THE CITY OF SAN DIEGO

Report to the Planning Commission

SUBJECT: 7354 Romero Drive Variance and Coastal Development Permit, Process Three Decision Appeal

PROJECT NUMBER: PRJ-1101825

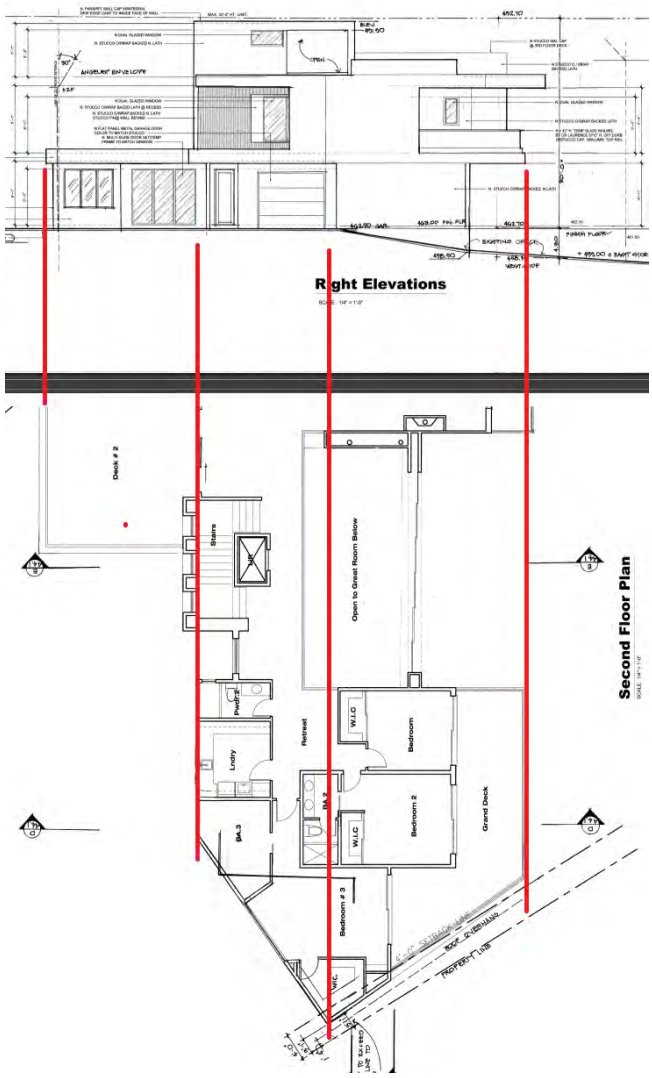
> *PROJECT PLANS: The project plans considered by the Hearing Officer are inconsistent and inaccurate.*

- *Sheet A1.1* *Does not accurately depict the walls that were demolished.*
- *Sheet A3.0* *Front elevation does not show roof eaves.*
  Rear elevation does not accurately reflect wrap-around balcony on west side of structure.
  Rear elevation shows second floor cantilever that is not reflected on floor plans.
- *Sheet A3.1* *Right elevation does not accurately reflect reduced balconies.*
- *Sheet 4.0* *Section A shows a cantilevered second floor on east and west side that is not reflected on the floor plans or elevations.*

Sheet A3.1: See the composite diagram to the right, which shows the floor plan with red lines leading up to the elevation. The elevation and decks align accurately. Staff analyzed these elevations for conformance to various measurements of height, existing grade, and proposed grade.
